# Blue Print ADM59860

to fit:  
Mazda RX8

## Mazda RX8 – Expansion Tank Coolant Level

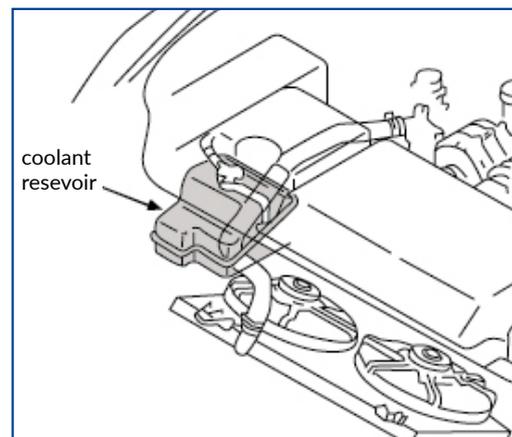
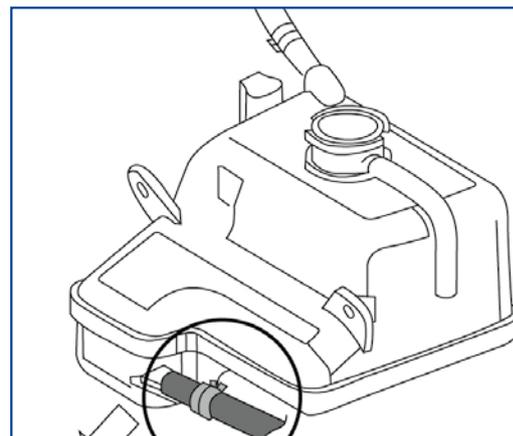
The coolant level sensor float is a common failing part on the Mazda RX8.

This is caused by surface deterioration of the sensor float which allows it to absorb coolant, causing the float to sink and give a false reading.

The coolant level light on the dashboard either stays on or flashes indicating a low coolant level, even when the coolant level is actually correct.

The sensor and float are not available separately, meaning the only permanent repair is to replace the complete Expansion Tank assembly.

Blue Print now supplies an OEM quality **Expansion Tank** with a revised specification coolant level sensor float – **ADM59860** – which is covered by Blue Print's comprehensive Three Year Warranty.
